**Re: Sprinstone parking
Davenport st NW
Traffic Circulation Layout**
Engineer's/Architect's Stamp 09-18-2019 (C12D003B2)

Based upon the information provided in your submittal received 09-18-2019, the above referenced plan cannot be approved for Building Permit until the following comments are addressed:

SPRINGSTONE PARKING LOT AND GARAGE TRAFFIC CIRCULATION PLAN

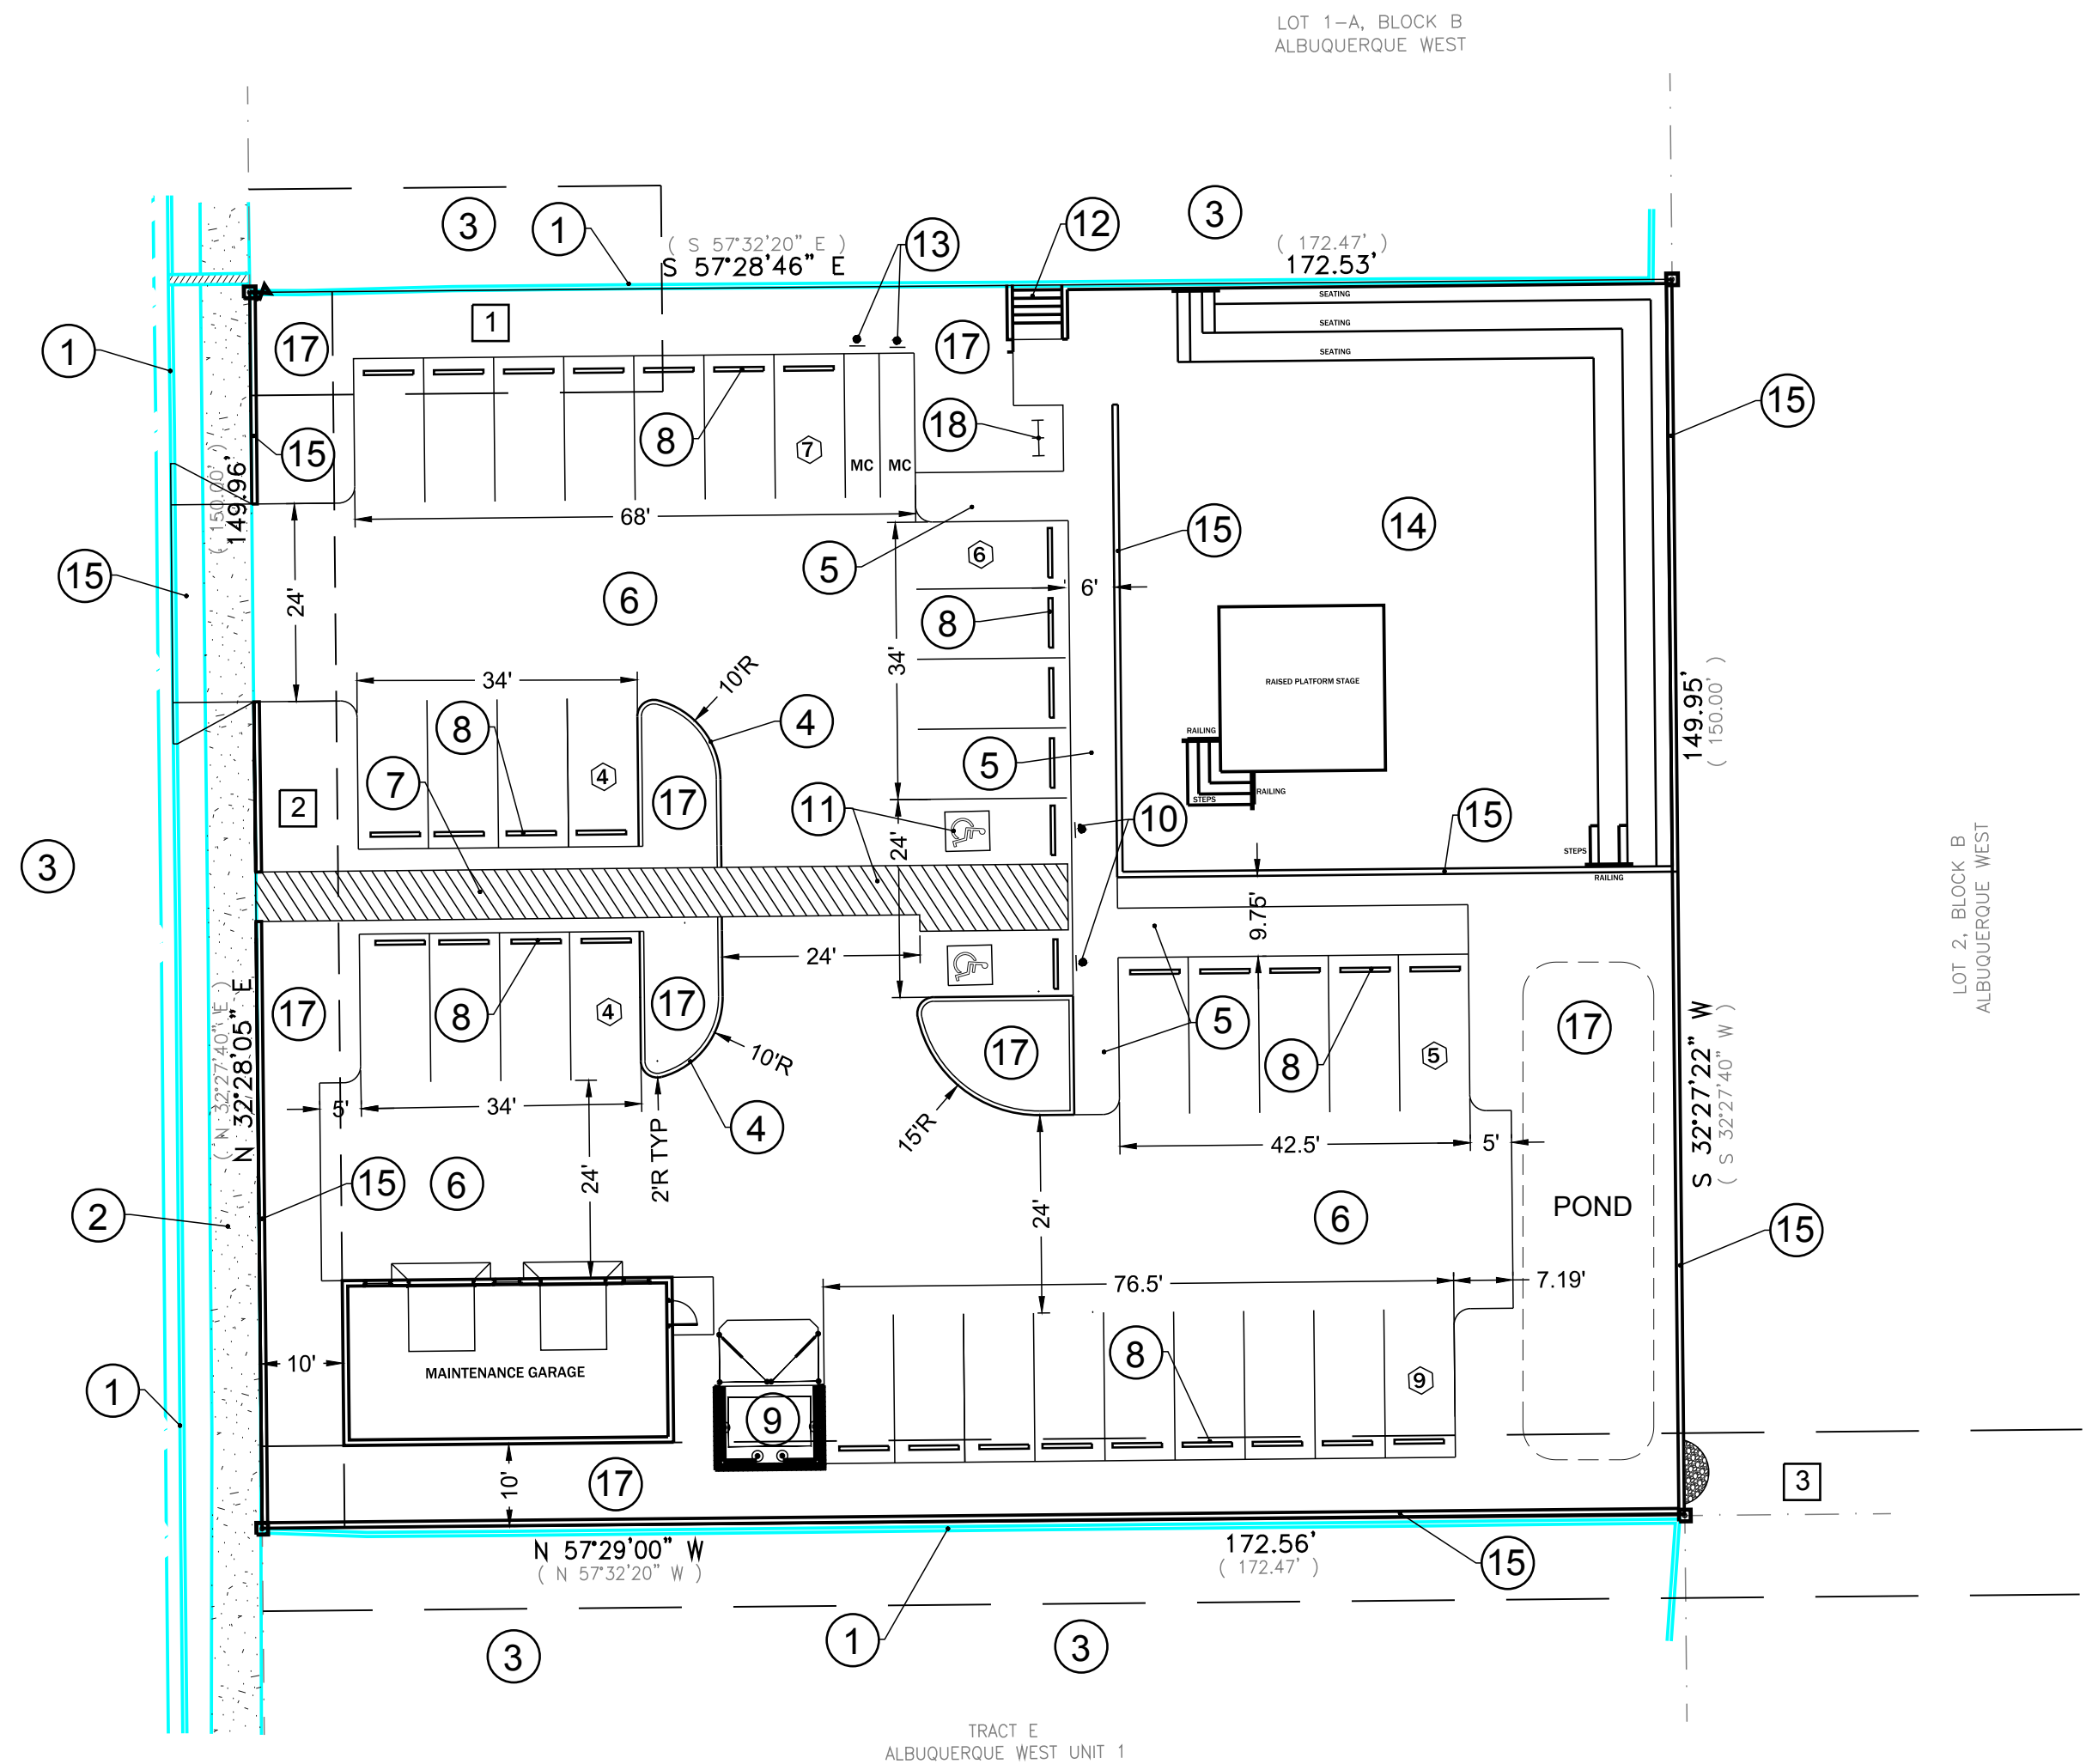
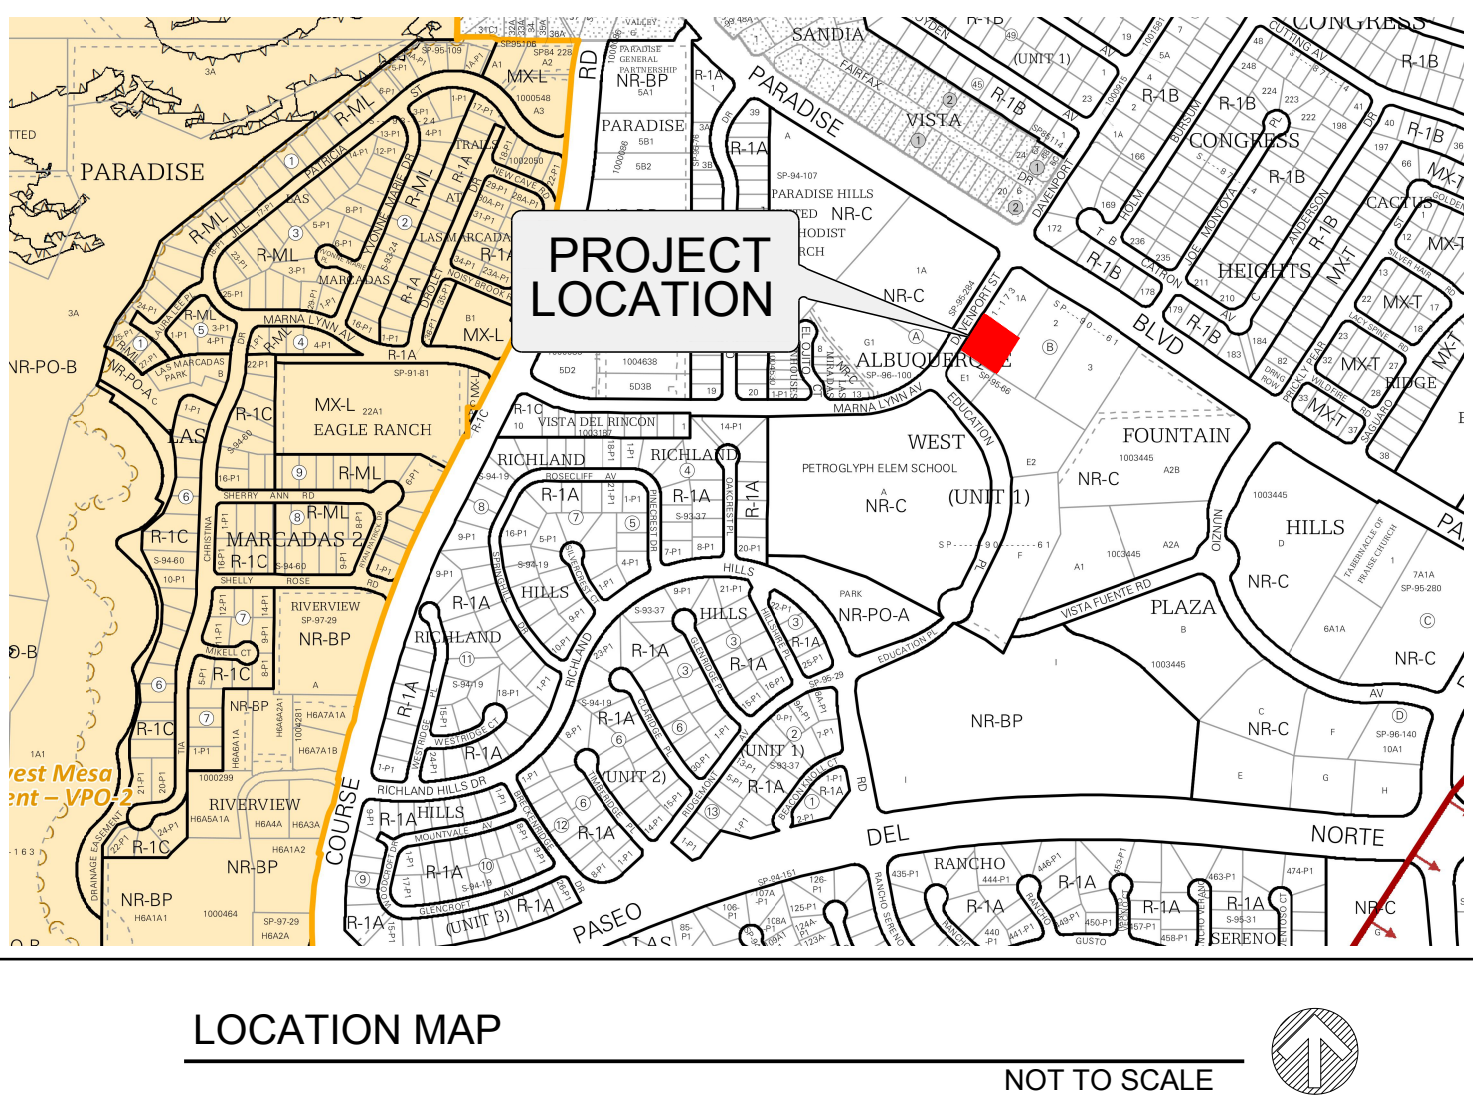
1. The ADA access aisles shall have the words **"NO PARKING"** in capital letters, each of which shall be at least one foot high and at least two inches wide, placed at the rear of the parking space so as to be close to where an adjacent vehicle's rear tire would be placed. (66-1-4.1.B NMSA 1978)

2. All bicycle racks shall be designed according to the following guidelines:
 - a. The rack shall be a minimum 30 inches tall and 18 inches wide.
 - b. The bicycle frame shall be supported horizontally at two or more places. Comb/toaster racks are not allowed.

- c. The rack shall be designed to support the bicycle in an upright position. See the IDO for additional information.
 - d. The rack allows varying bicycle frame sizes and styles to be attached.

- e. The user is not required to lift the bicycle onto the bicycle rack.
 - f. Each bicycle parking space is accessible without moving another bicycle.

3. Bicycle racks shall be sturdy and anchored to a concrete pad.
4. A 1-foot clear zone around the bicycle parking stall shall be provided.
5. Bicycle parking spaces shall be at least 6 feet long and 2 feet wide.

6. Per DPM, a 6 ft. wide ADA accessible pedestrian pathway is required from the ADA parking stall access aisles to the building entrances. Please clearly show this pathway and provide details.

7. Refuse vehicle maneuvering shall be contained on-site. The refuse vehicle shall not back into the public right of way.; **provide a copy of refuse approval.**
8. It is not apparent what type of pavement surface is being proposed. A hard driving surface will be required as part of this proposed project for parking area and drive aisles.
9. Show the clear sight triangle and add the following note to the plan:
"Landscaping and signage will not interfere with clear sight requirements. Therefore, signs, walls, trees, and shrubbery between 3 and 8 feet tall (as measured from the gutter pan) will not be acceptable in the clear sight triangle."
